Subject: Old Town Escape Barn Assessment Letter; Project No. 658052,  
Internal Order No. 24008534, Old Town

The Development Services Department has completed the Second review of the project referenced above, and described as:

Planned Development Permit and Conditional Use Permit for an escape room with two residences, located at 3886 Ampudia St. The 0.11-acre site is in the OTMCR-1-2 Zone, within the Old Town San Diego Community Plan area.

SCALE: 1/4" = 1'-0"

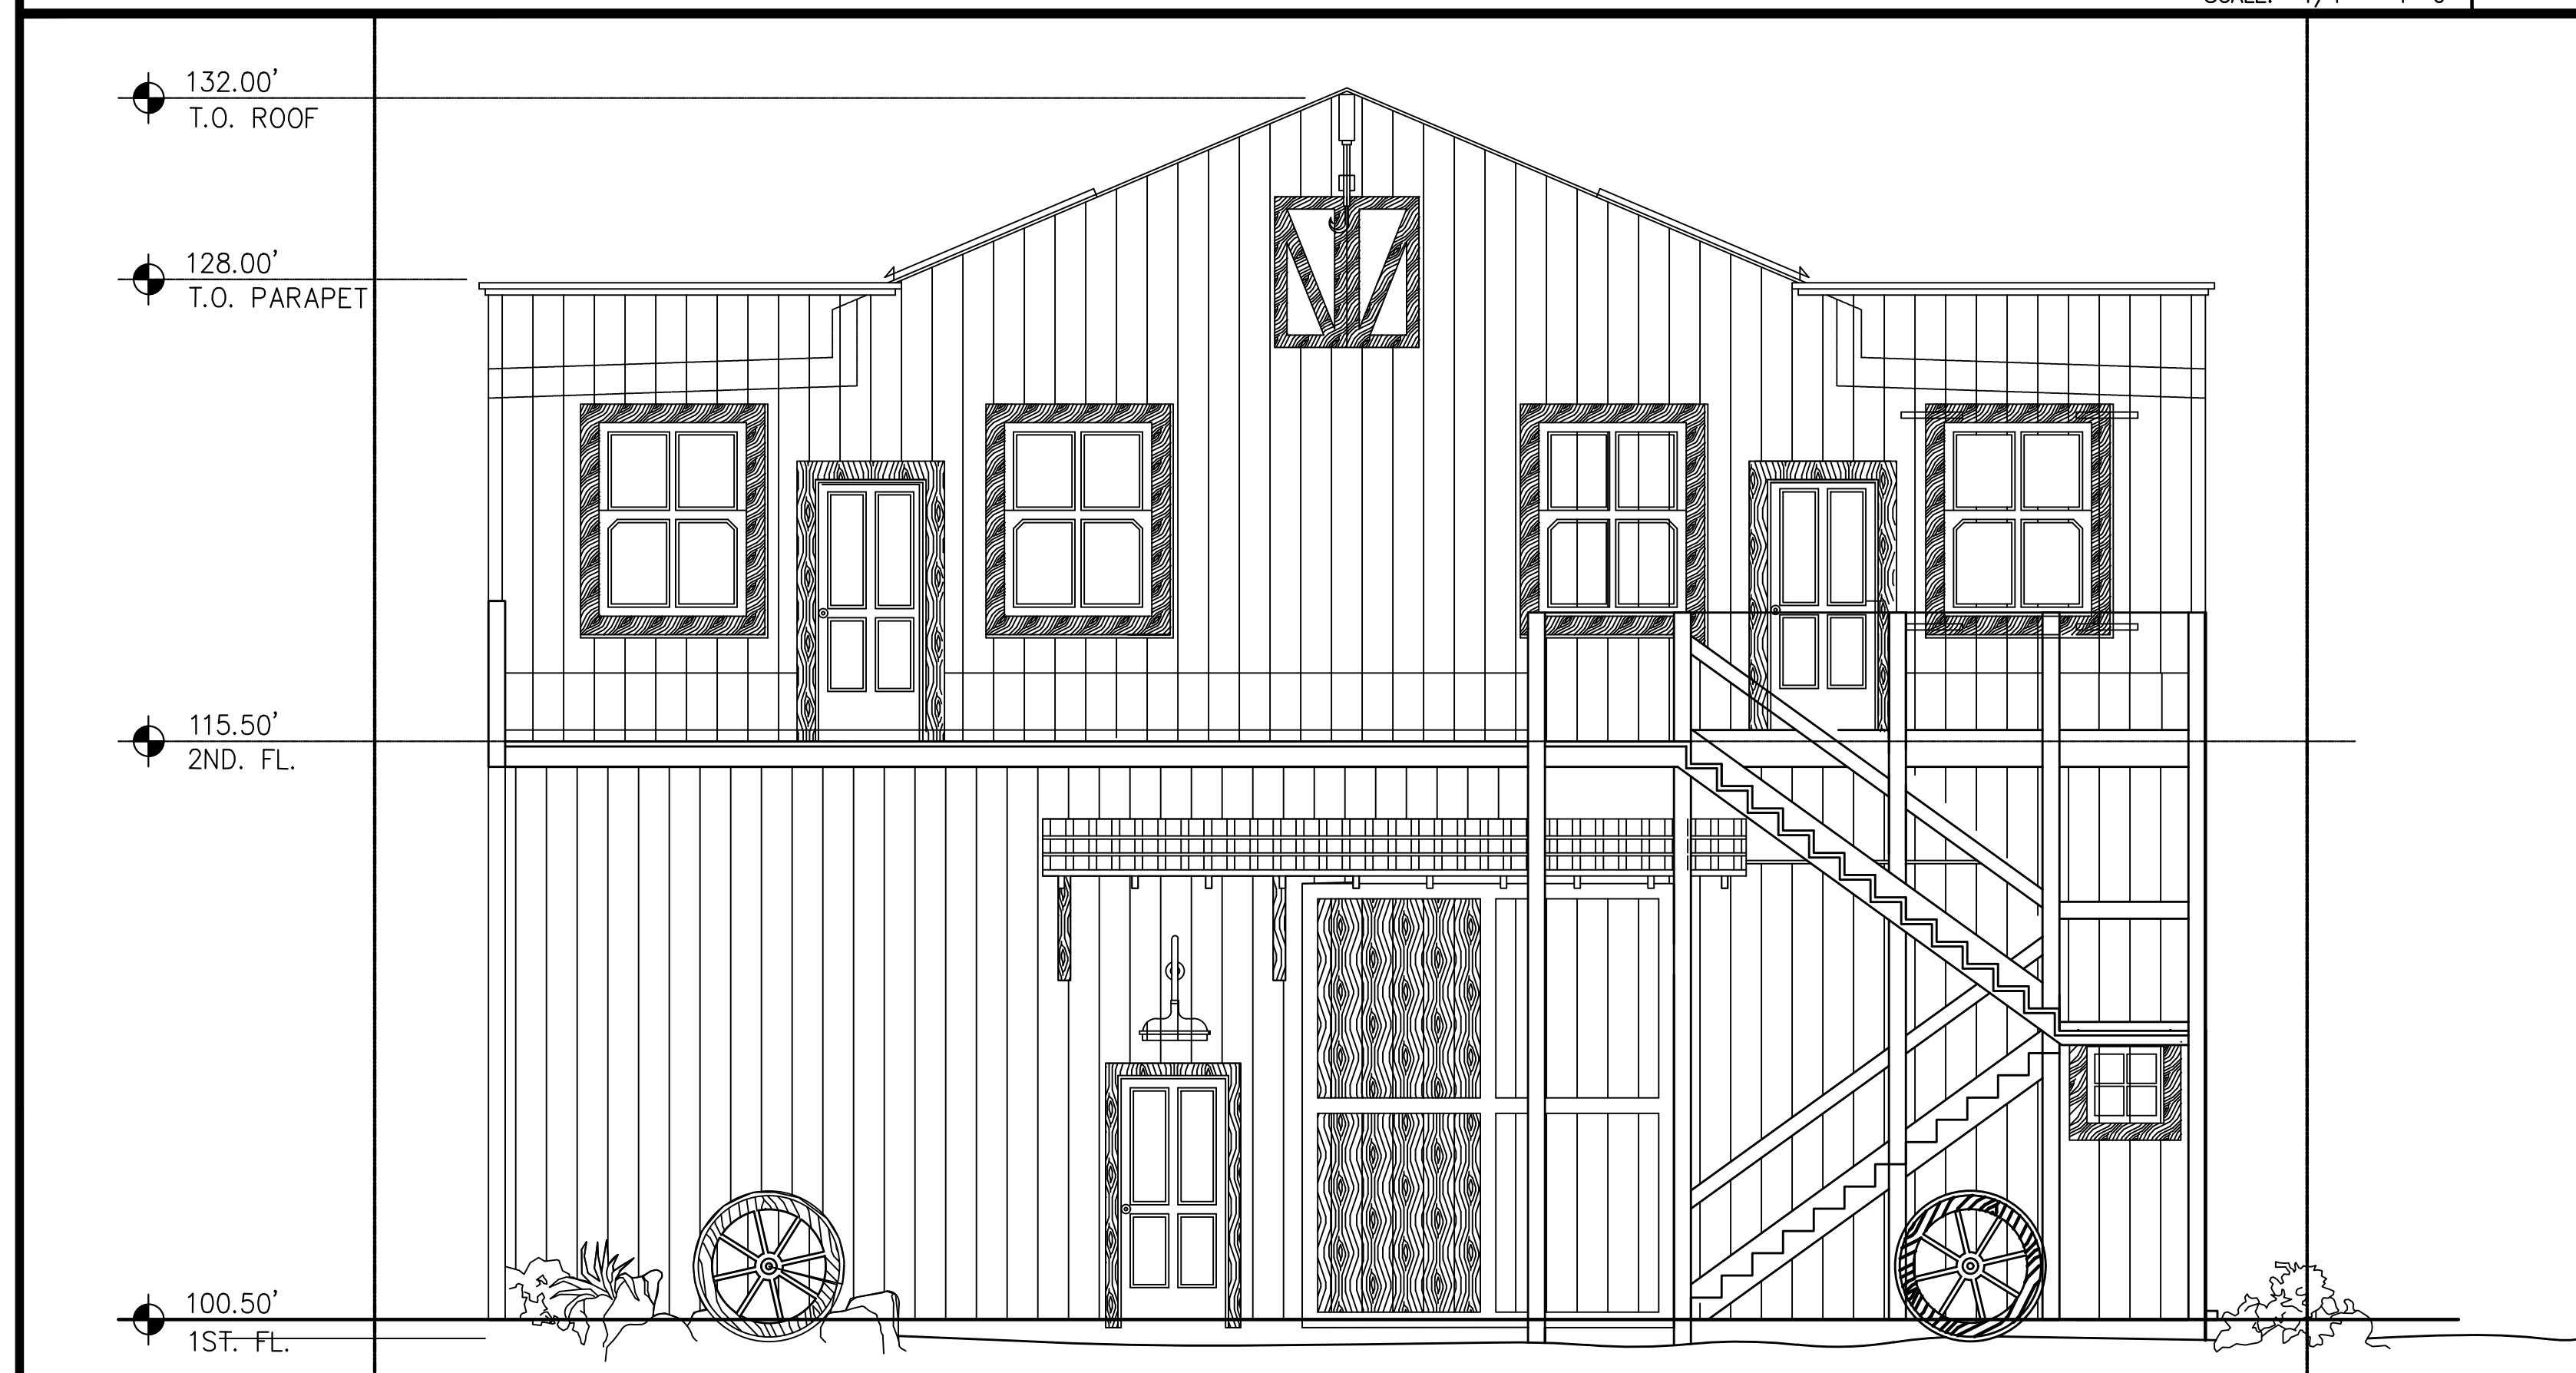
<u>Cleared?</u>	<u>Issue Num</u>	<u>Issue Text</u>
<input type="checkbox"/>	10	Please correct the Keynotes 9 and 10 on sheets 6 and 7; they are mislabeled. Keynote 9 states that the existing window to remain, but it is labeled on a door and Keynote 10 states existing door to remain, and it is labeled on a window. (From Cycle 2)
<input type="checkbox"/>	11	Please correct the sheet number within the note on Sheet 1 that states "Demolish and Reconstruct Parking Lot. See Sheet 9 for conceptual Landscape Plan". The Landscape Plan is on Sheet 11 (not Sheet 9) - the note needs to be corrected to reflect this change. (From Cycle 2)

# Landscape Concept Plan

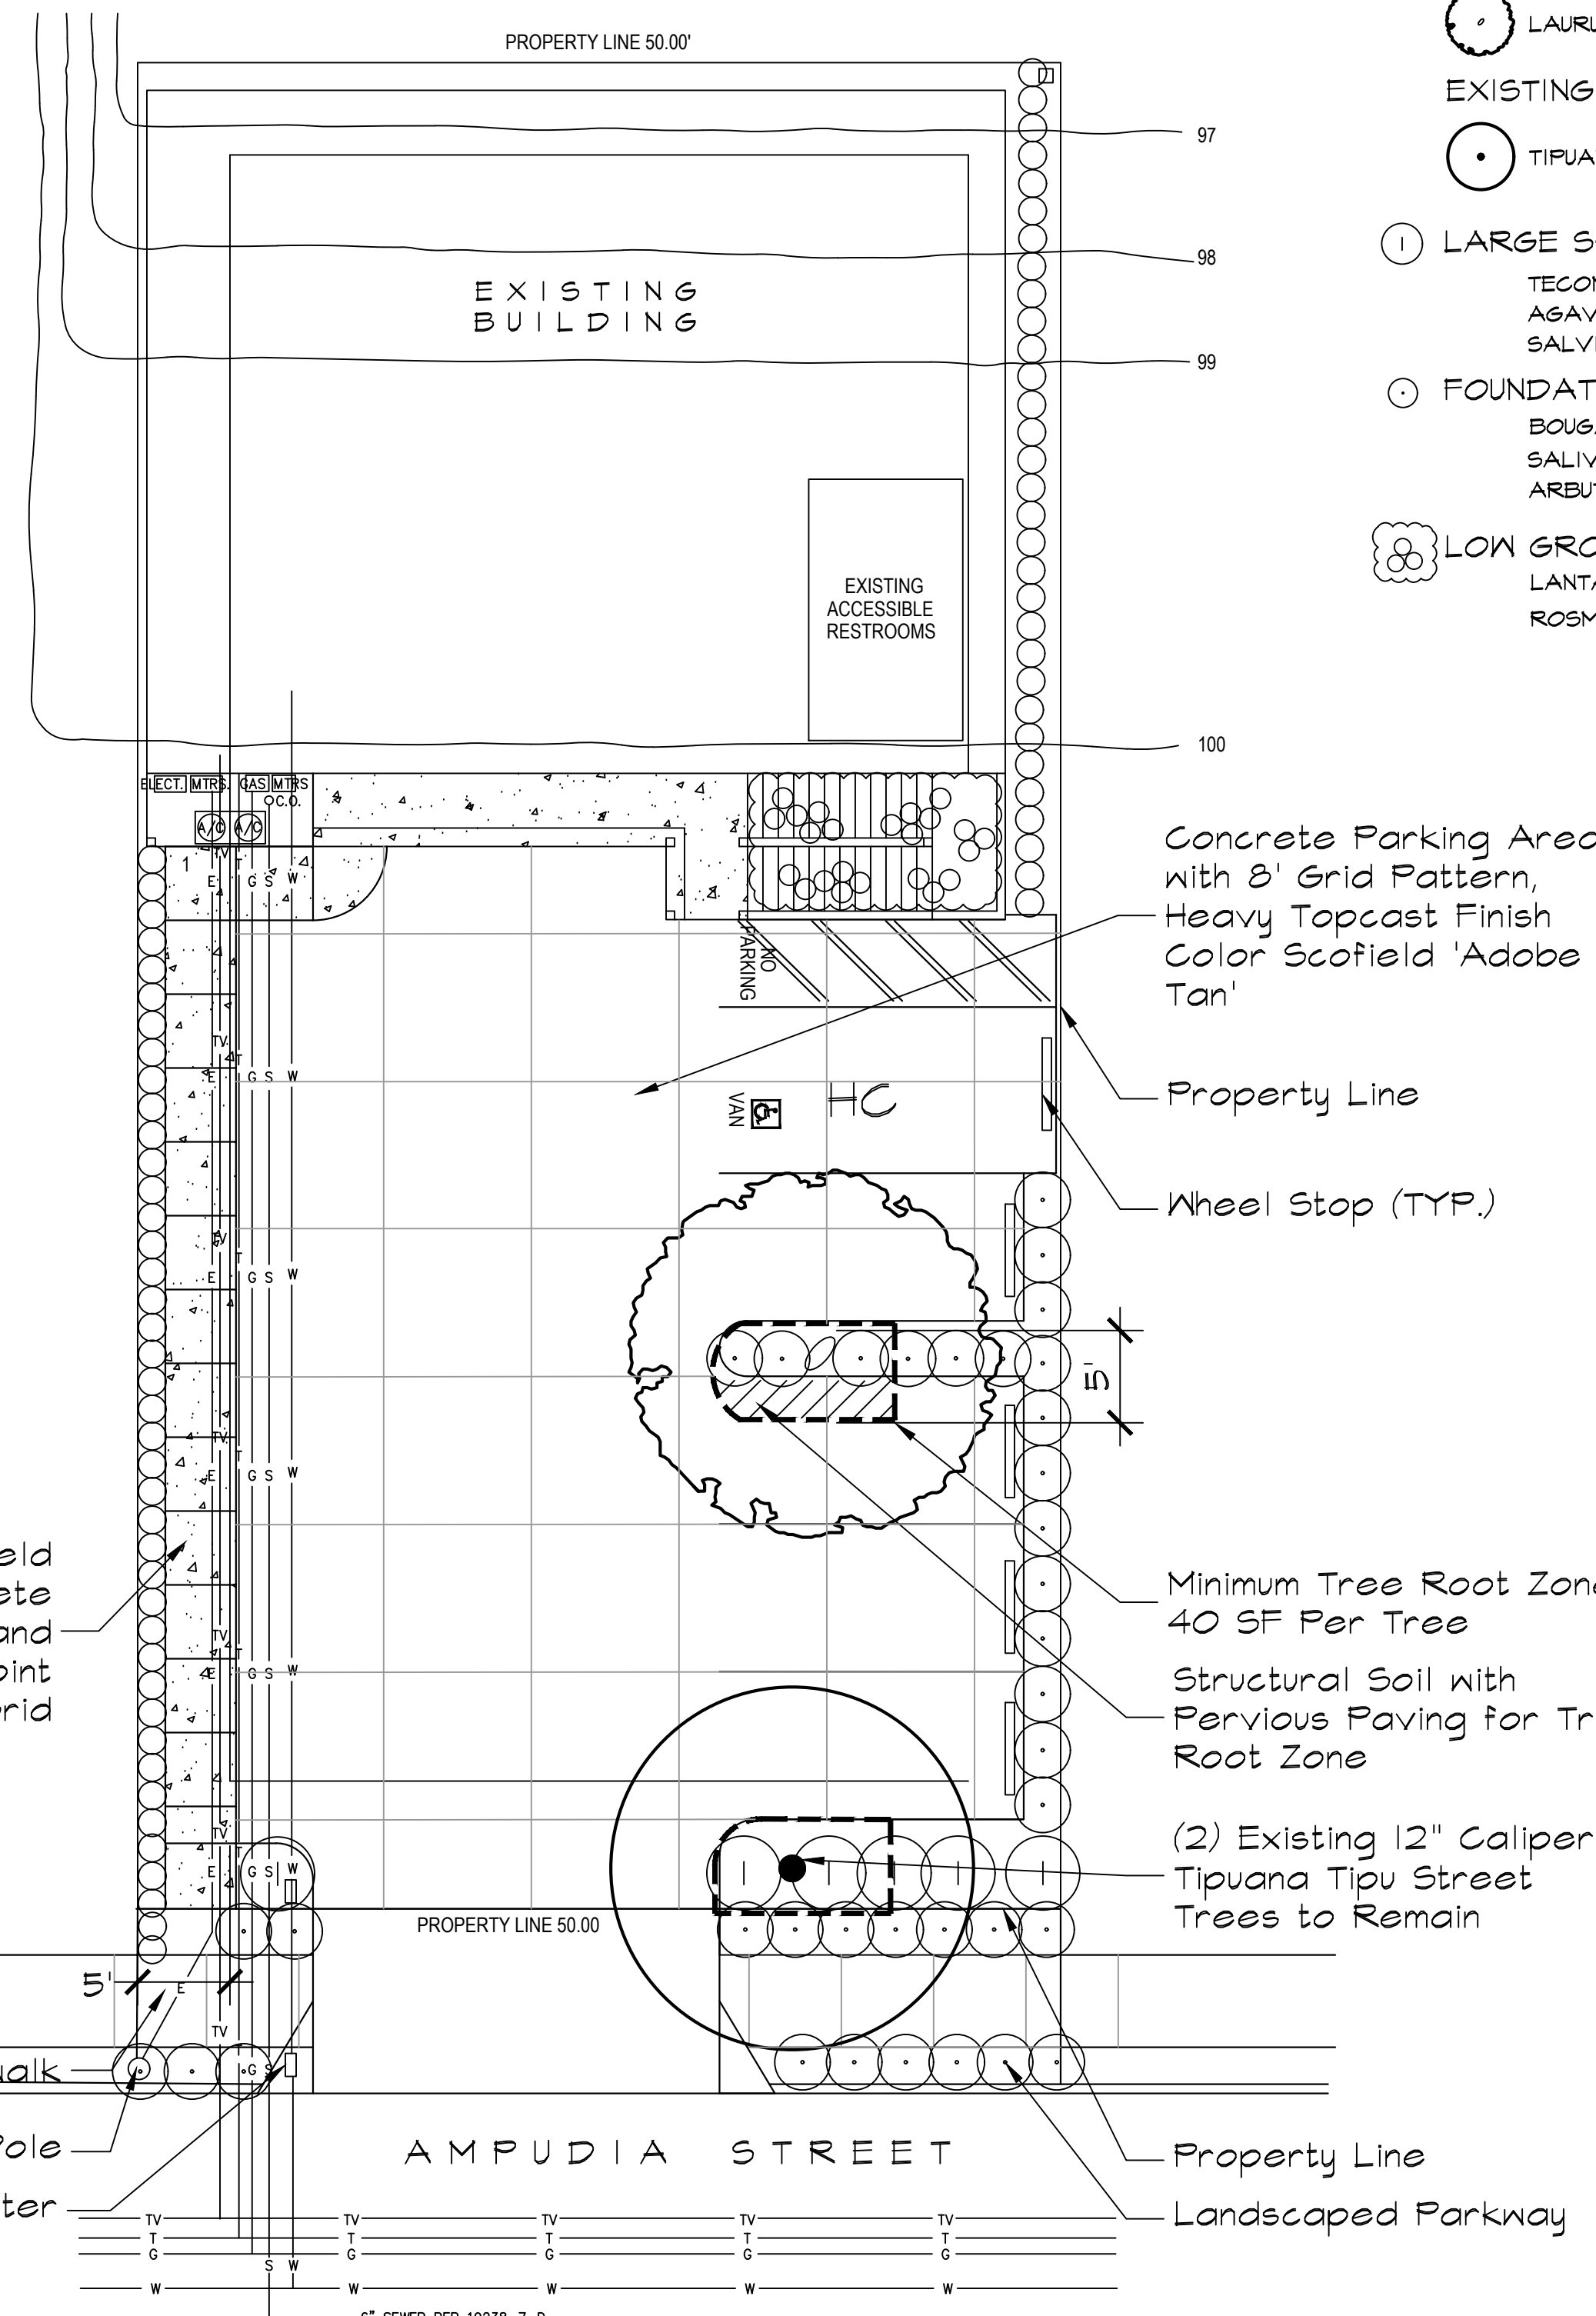
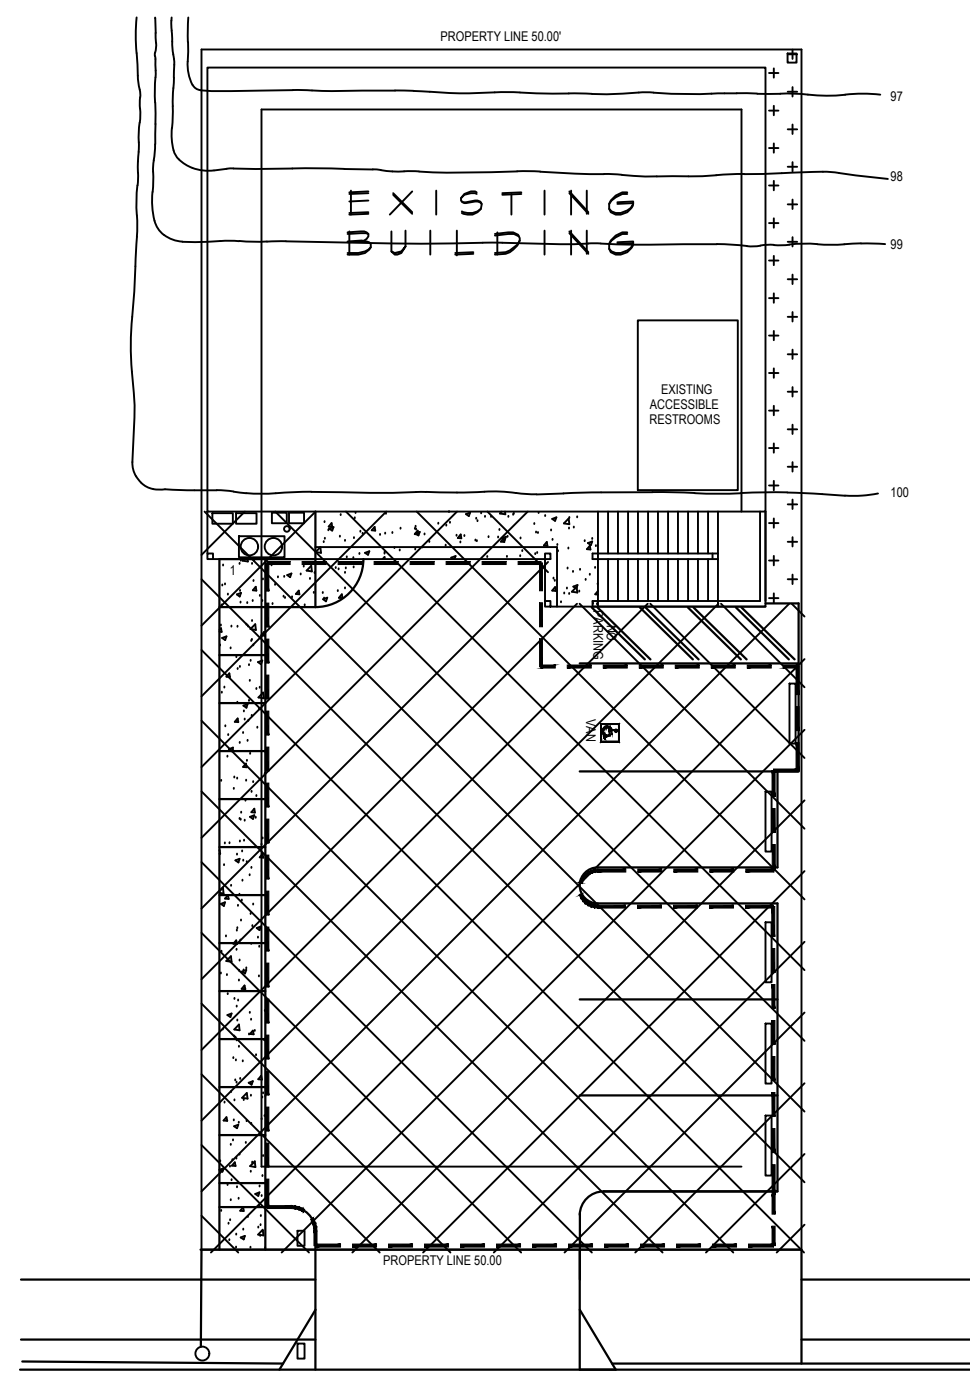
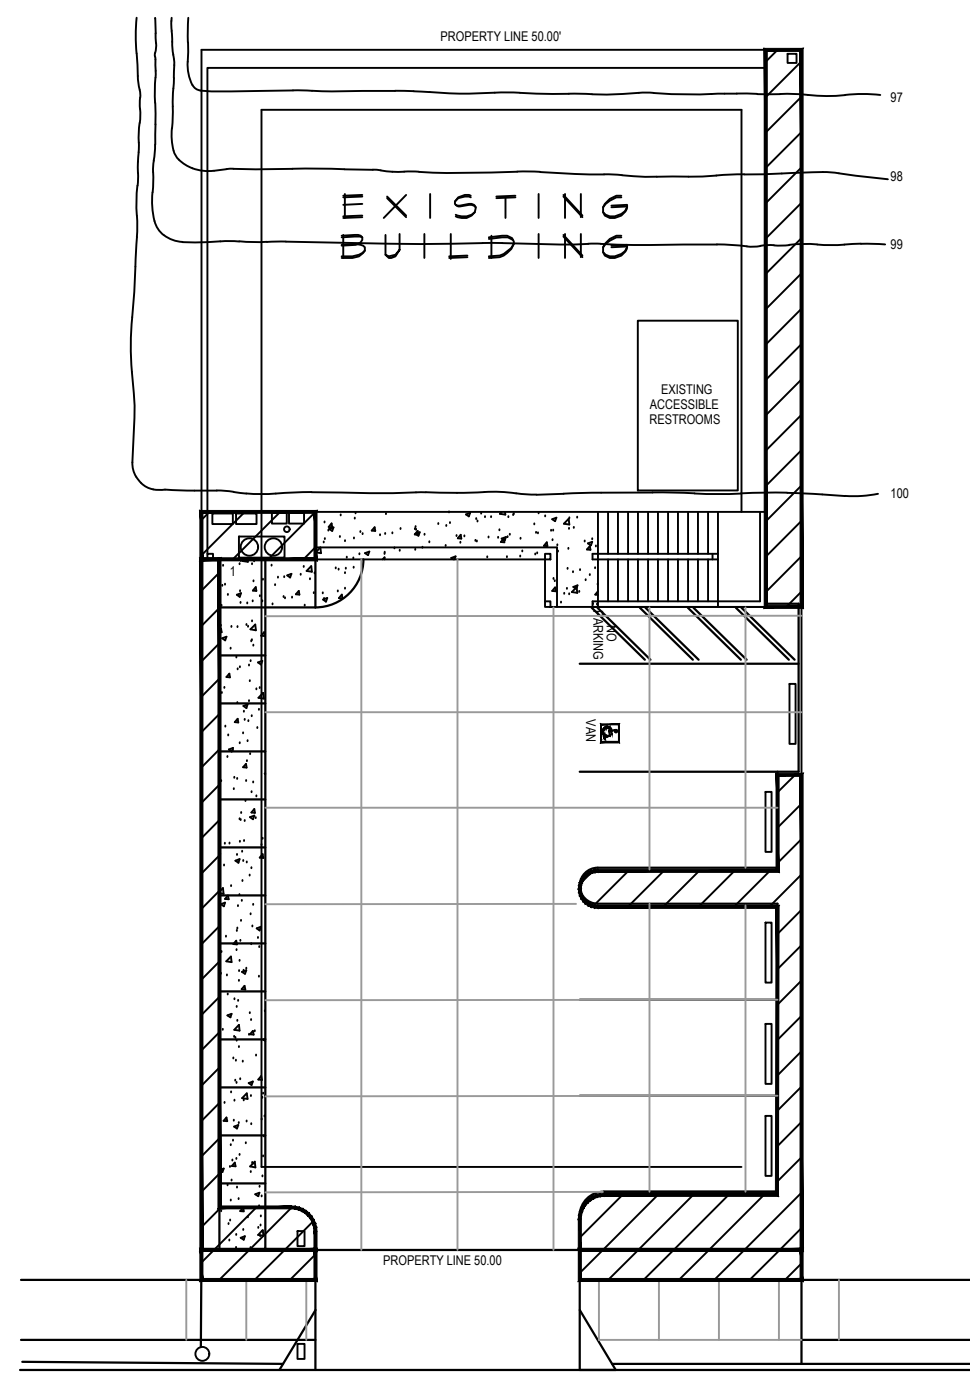
<u>Cleared?</u>	<u>Issue Num</u>	<u>Issue Text</u>
<input type="checkbox"/>	13	On the landscape plan, Sheet 11, please correct the common name of the large shrub "Tecoma Stans": from "Orange Bells" to "Yellow Bells" for consistent nomenclature with the plant list in Table 5-2: Planting Palette B - Landscape Tree and Shrub Species located on pages 109-110. (New Issue)

<u>Cleared?</u>	<u>Issue Num</u>	<u>Issue Text</u>
<input type="checkbox"/>	14	In reference to the Parking Lot Design, Sheet 11: please refer to Policy UD-4.22: "Design the interior of parking areas in a manner representative of a rural context, with dirt landscaped islands with arid landscaping and gravel-textured rural-type concrete or other soil-colored paving material. Discourage use of black asphalt and other dark colored asphalt as parking lot paving material to reduce the urban heat island effect." (Urban Design Element: Page 95) (New Issue)
<input type="checkbox"/>	15	The proposed 8' grid layout throughout the entire parking lot is too decorative and evokes a pattern that is too similar to the adjacent sidewalk. This design is also not consistent with Policy UD-4.22 "...gravel-textured rural-type concrete". A single pour is preferred to meet the policy; but if a segmented pour is considered, perhaps to avoid future cracking in the cement, a larger pattern should be proposed and illustrated on the plans. (New Issue)

<input type="checkbox"/>	16	The color proposed for the Parking lot, "Scofield Adobe Tan", is not consistent with Policy UD-4.22. The policy states that a "...gravel-textured rural-type concrete or other soil-colored paving material." Staff does not view the "Scofield Adobe Tan" color as similar to that of the natural soil. Please choose a color that is consistent with the policy as stated above and provide color samples in your next submittal. (New Issue)
